State of Oregon Department of Environmental Quality

Written Comments

Willamette Subbasin TMDL

This document is a compilation of written comments received during the public comment period for the Willamette Subbasins TMDL.

Figure 3. Comparison of DEQ Restored Conditions scenario to Contiguous 25% Disturbance "By Node" Scenario for Middle Mosby Creek.

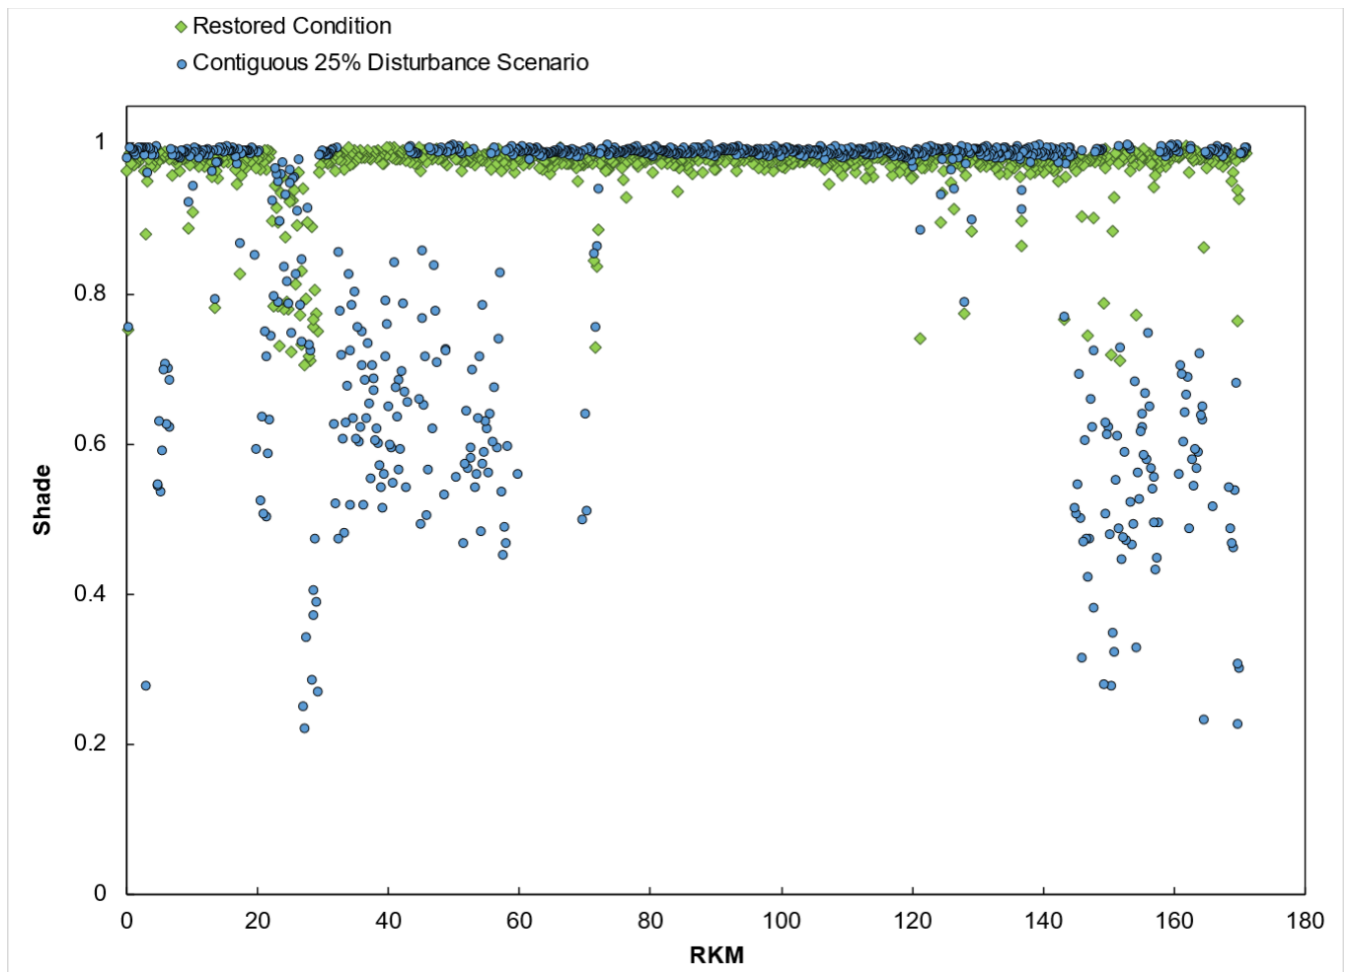
We ran the shade model provided by DEQ for the condition described above and compared the results to the output for Middle Mosby Creek for DEQ’s restored conditions scenario. Figure 3 presents a comparison of the modeled shade. Specifically, each green dot in Figure 3 represents

a modeled node from DEQ's restored conditions scenario. There is a corresponding blue dot for each modeled node using the Contiguous 25% disturbance scenario. The figure indicates that, for many nodes, there is slightly more shade under the Contiguous 25% disturbance scenario—this is because the vegetation surrounding these nodes is fully undisturbed under the Contiguous 25% disturbance scenario, whereas there is random disturbance included in the DEQ restored conditions scenario. However, Figure 3 also shows that for nodes modeled as “disturbed,” much less shade is provided under the Contiguous 25% disturbance scenario compared with the restored conditions scenario. Importantly, these nodes do not receive 0% shade—the disturbed forestland condition described in Appendix C of the still includes 56-foot tall trees with 25% density. Nevertheless, when averaged over the modeled nodes for Middle Mosby Creek, the restored condition average from the draft TMDL method for this subbasin is **97%**, while the average using the Contiguous 25% disturbance approach is **88%**. This analysis indicates that using a more realistic approach to modeling disturbance would result in a lower, and more justifiable, shade target.

We note again here that this example used a Contiguous 25% Disturbance, for purposes of comparison to DEQ's restored conditions scenario. However, based on our review of the literature, we request that DEQ use 35% disturbance.

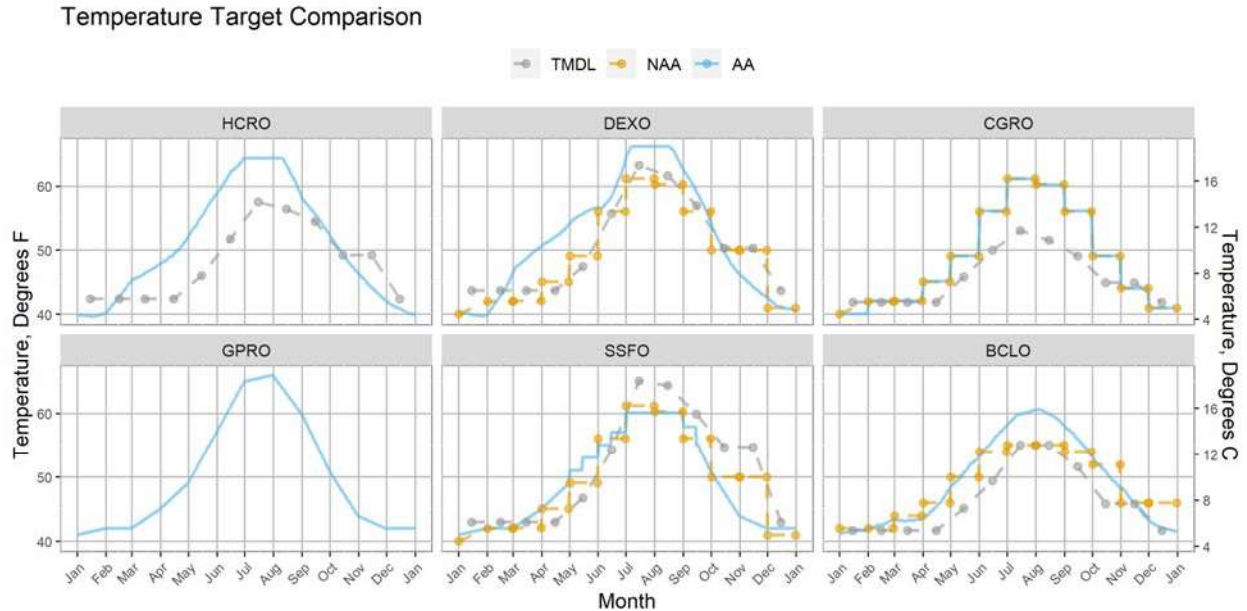
accumulated heat in the epilimnion in summer, thereby reducing release temperatures in autumn when the lake level and thermocline are dropping in elevation to meet the lower outlets. The likelihood of making real improvements to water temperature will improve if criteria and target development is coordinated and relevant for DEQ, NMFS, and the Corps.
